SUBJECT: ENSR Trip Report – JDA North Ladder

PROPOSED COUNT STATION MODIFICATIONS

By
Project Fisheries
The Dalles and John Day Projects
U.S. Army Corps of Engineers

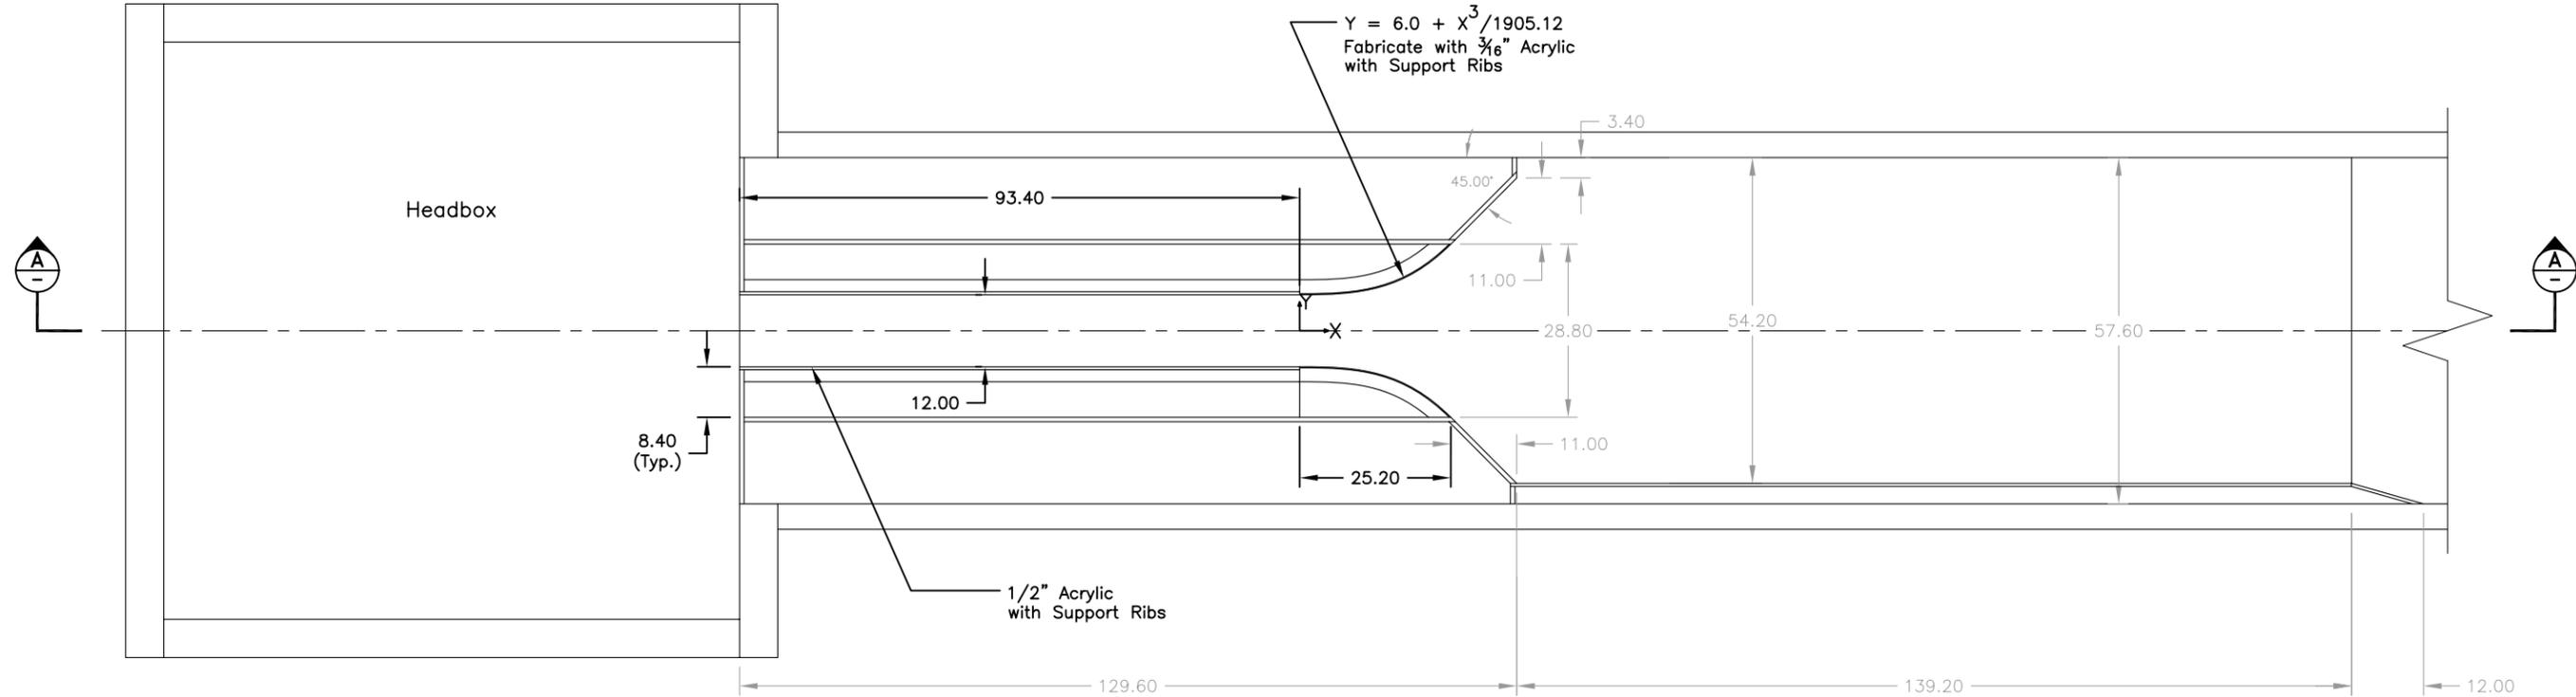
USACE will confirm whether Weirs No. 18 through 20 need to have wider slots (18" wide) at low flows to meet the pool depth criterion.

Figure 1 - Comparison of Pool Flow Patterns With Sill and Without Sill in Upstream Weir

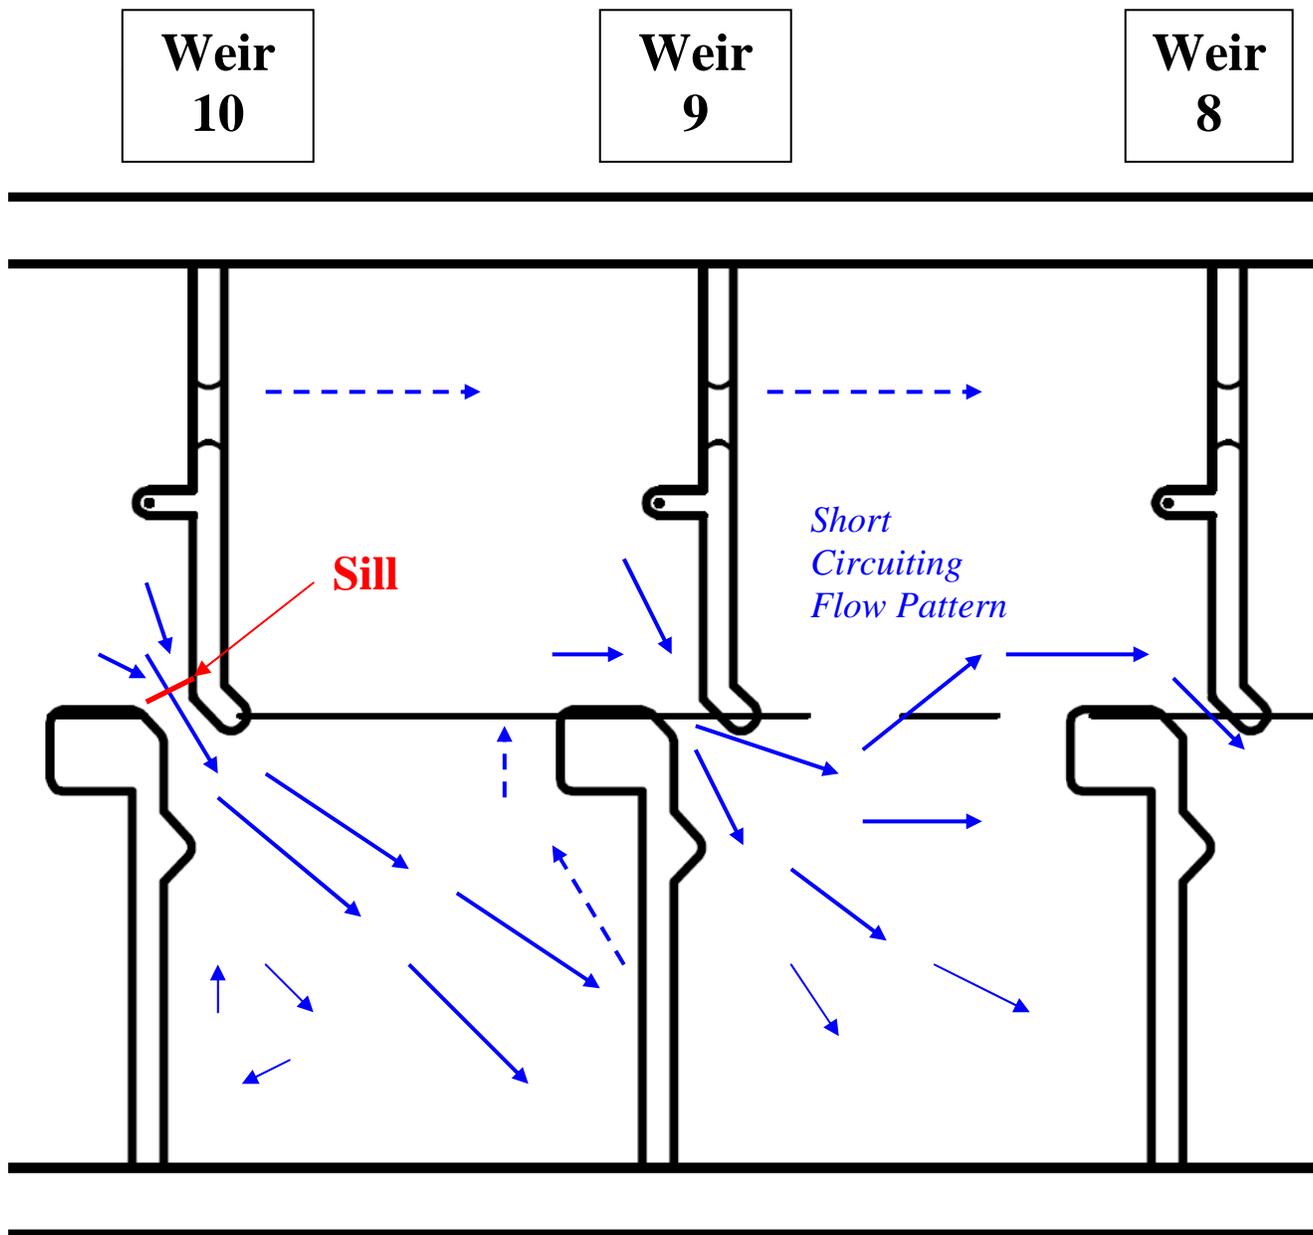
For pool without the sills, the flow pattern is characterized by short-circuiting between vertical slots (see right pool between Weirs 8 & 9 in Figure 1). Short-circuiting is an issue inherited from the previous John Day South Exit Study conducted at NHC lab in 2001. It was considered an indicator of insufficient energy dissipation. Energy dissipation became a major concern, when they encountered ladder instability in the form of heavy seiching in the first tests at NHC lab. However with the Lamprey weir study, there are plenty of cases of short-circuiting but little or no evidence of ladder instability. One reason that short-circuiting does not appear to be a problem in the Lamprey friendly weirs is likely the diffusive nature of the vertical jet discharge. Because of the rounded corners around the opening of the slot, the outlet jet through the slot is not contracted, less concentrated and more flaring with radial distance from the slot. Natalie diligently noted locations of short-circuiting during most tests. Both Gary and Steve doubt the short-circuiting is a biological problem as long as the system does not become unstable. However, the change in hydraulic conditions between pools with and without sills does represent a risk that merits concern.
